UNITED STATES PATENT AND TRADEMARK OFFICE

APPLICATION NO.	FILING DATE	FIRST NAMED INVENTOR	ATTORNEY DOCKET NO.	CONFIRMATION NO.
09/965,509	09/26/2001	Cem Basceri	6047-59403	3307

Office Action Summary

DETAILED ACTION

FIG.4

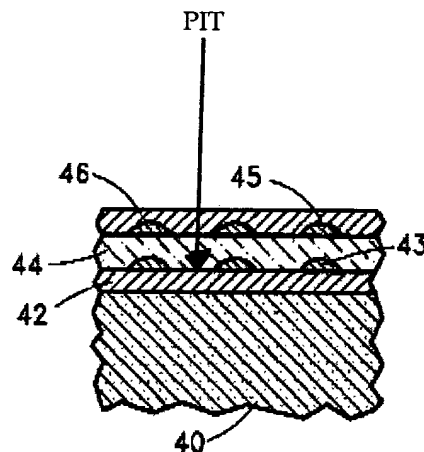
Laibowitz et al. disclose a capacitor structure (fig. 4 and col. 6, lines 8-31). The capacitor structure comprises the following elements: a support structure 40 (fig. 4); a conductive layer having a pitted surface 43 (fig. 4); a layer of dielectric material 44 disposed on the pitted surface (fig. 4); and a continuous layer of conductive material 46 disposed on the layer of dielectric material (fig. 4). The conductive layer 43 is formed on a first conductive layer 42. Together, the conductive layers form the lower electrode of a capacitor structure.

Laibowitz et al. disclose a capacitor structure in an integrated circuit (fig. 4 and col. 6, lines 8-31). The structure comprises: a layer of conductive material 42 with islands 43 disposed thereon (fig. 4); a layer of dielectric material 44 disposed conformally on the islands (fig. 4). A layer of conductive material 46 is disposed conformally on the layer of dielectric material (fig. 4). Together, the layer of conductive material 42 and the islands 43 form the lower electrode of a capacitor structure.

4. Applicant's arguments filed 17 November 2003 have been fully considered but they are not persuasive.
5. The Applicant argues that Laibowitz does not teach a ruthenium oxide pitted surface, and that Kang does not teach a ruthenium oxide layer having a pitted surface. Laibowitz discloses a capacitor structure (fig. 4). The capacitor's lower electrode comprises a first layer - conductive layer 42, and a second layer - conductive islands 43. The conductive layer 42 and islands 43, combined, form a conductive layer having a pitted surface.¹

Whereas the conductive layer having a pitted surface comprises a metal layer such as Ru (col. 6, lines 22-26), Laibowitz does not teach that the conductive layer comprises

RuO₂. The Kang patent is relied upon only because it teaches that RuO₂ may be used in place of Ru as a material for a lower electrode in a capacitor structure of an integrated circuit. Kang need not teach a ruthenium oxide having a pitted surface, since the primary reference, Laibowitz, is relied upon for that teaching. It is the examiner's position that, combined, Laibowitz and Kang disclose a conductive layer comprising a ruthenium oxide layer having a pitted surface.
